February 12, 2008

Serial No. 07-0109G
SPS-LIC/CGL R0
Docket Nos. 50-280
50-281
License Nos. DPR-32
DPR-37

VIRGINIA ELECTRIC AND POWER COMPANY
SURRY POWER STATION UNITS 1 AND 2
MCR AND ESGR AIR CONDITIONING SYSTEM CHILLED WATER PIPING
REPLACEMENT PROJECT – PHASE III SCOPE MODIFICATION

**MCR / ESGR
CHILLED WATER
SYSTEM
PHASE III
FIGURE 6**

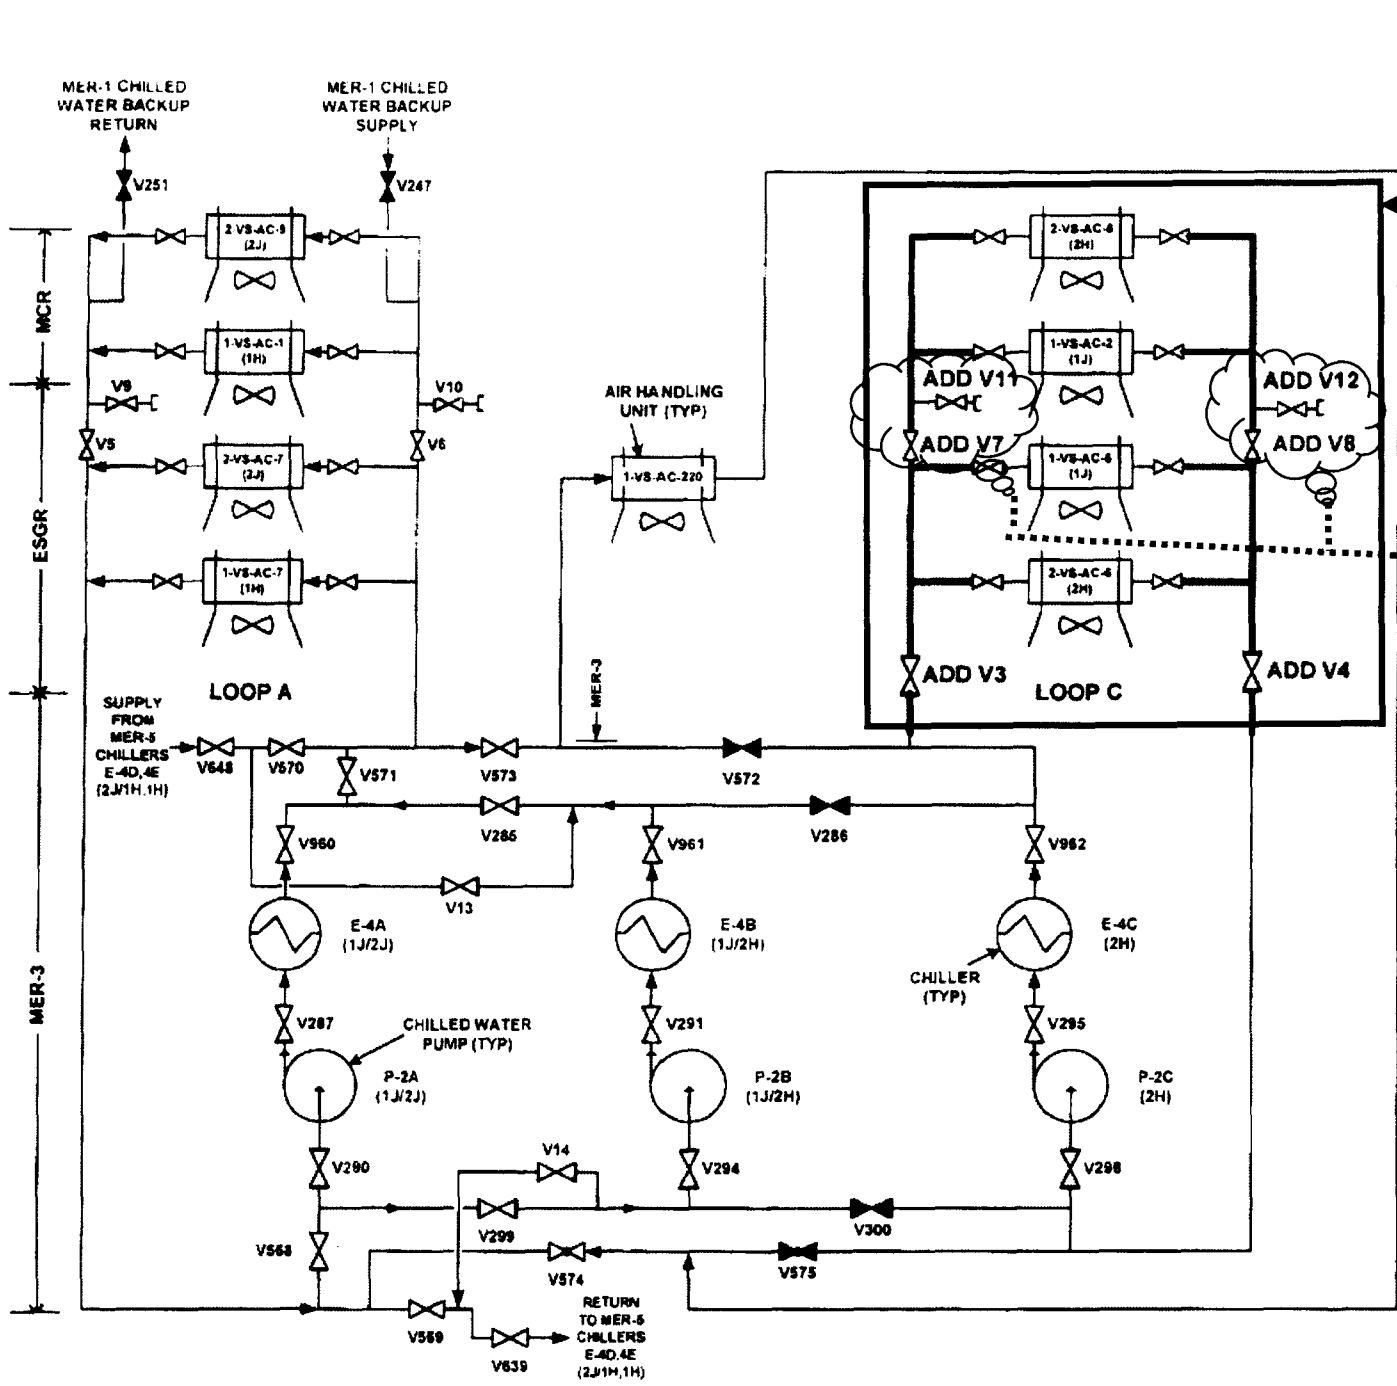
As shown in the attached Figure 6, isolation valves V7 and V8, as well as valves V11 and V12/hose connections, will not be installed as part of Phase III due to unavailability of these components prior to the completion of Phase III. As discussed in the following paragraphs, this scope modification is not of concern with respect to either the piping replacement project or the temporary risk-informed 45-day AOT for Phase III; however, we are advising you of the scope modification, since it is a change to the submitted description of Phase III. These isolation valves and valves/hose connections will be installed following completion of Phase III but before the start of Phase IV, currently scheduled to begin on August 11, 2008. Installation of these components will be accomplished within the existing 7-day TS 3.23 AOTs for AHU inoperability (i.e., TS 3.23.C.2.a.1 and TS 3.23.C.2.b.1). This activity is consistent with Phase II, during which the valves and valves/hose connections serving the same function were installed on chilled water loop A.

Isolation valves V7 and V8, as well as isolation valves V3 and V4 (which will be installed during Phase III), are being installed to facilitate future maintenance activities following completion of the piping replacement project. Such future maintenance activities will use the existing 7-day TS 3.23 AOTs for AHU inoperability (i.e., TS 3.23.C.2.a.1 and TS 3.23.C.2.b.1). Valves V11 and V12/hose connections are being installed to accommodate hook up of the chilled water backup supply from the MER-1 chillers (1-VS-E-3A, 1-VS-E-3B) if needed during the subsequent phases of the piping replacement project. As noted above, these valves and valves/hose connections will be installed after Phase III and before Phase IV, which is prior to possible use of these components.

Entry into the additional (deterministic-based) TS 3.23 7-day AOTs to install these valves and valves/hose connections does not impact the probabilistic risk assessment (PRA) performed for the temporary 45-day and 14-day (risk-informed) AOTs. However, even if the additional 7-day AOT entry were considered with respect to the PRA, the PRA would remain bounding since it was performed for four 45-day AOT entries (180 days). Entries into the two 45-day AOTs, the two 14-day AOTs, and this additional TS 3.23 7-day AOT total 125 days. Furthermore, the additional 7-day AOT entry will be accounted for with respect to the maintenance rule requirements of 10CFR50.65(a)(4) to satisfy the RG 1.177 Tier 3 configuration risk management program requirements.

Valves not being added in modified Phase III scope

During the first temporary AOT (45 days), (a) loop C piping will be replaced, (b) new loop isolation valves V3 and V4 will be added, and (c) new valves V7, V8, V11, and V12 will be added.
